From: Kulis, Jerzy, NMENV
Sent: Wednesday, April 28, 2010 12:26 PM
To: 'Everett, Mark C'; Dale, Michael, NMENV; Cobrain, Dave, NMENV
Cc: Shen, Hai; Mignardot, Edward R Jr; Whitacre, Thomas J; Ball, Theodore T; Lynnes, Kathryn D; Mike Klahn
Subject: RE: R-57 proposed well design

R-57 Well Objectives

R-57 Recommended Well Design

Figure 2. Proposed well design for R-57.

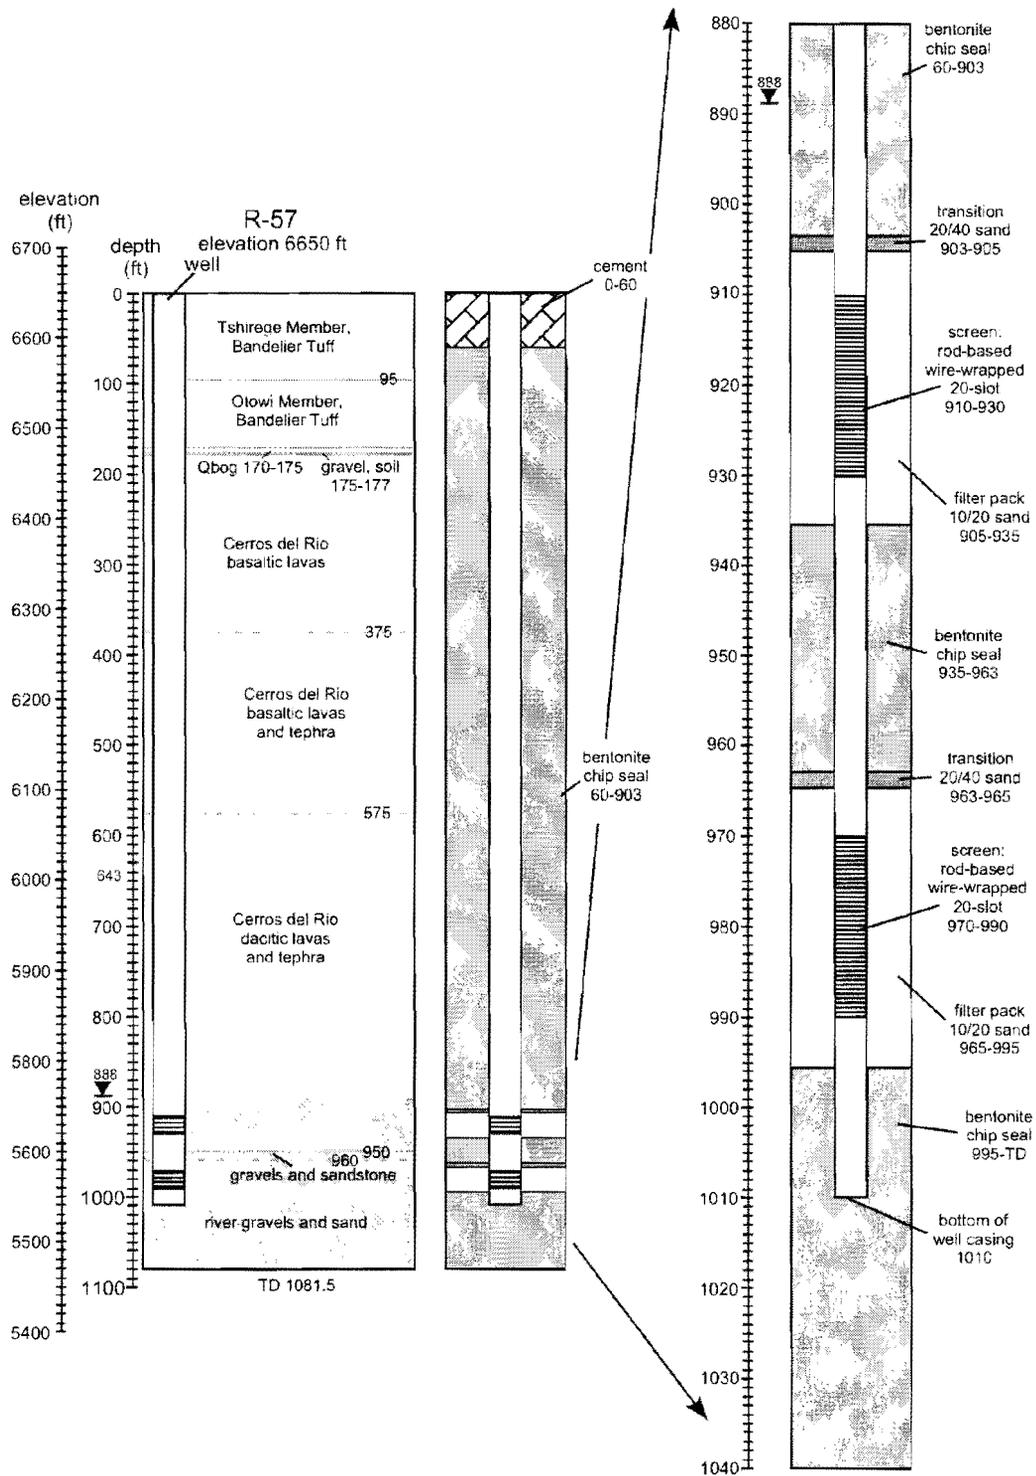
This e-mail serves as NMED approval for installation of regional aquifer well R-57 as proposed in the document attached to the original e-mail received by NMED on April 28, 2010 at 10:49 AM. This approval is based on the information available to NMED at the time of the approval. NMED understands that LANL will provide the results of preliminary water-quality sampling, any modifications to the proposed well design, and any additional information related to the installation of well R-57 as soon as such information becomes available. LANL shall give notice of this installation to the New Mexico Office of the State Engineer as soon as possible.
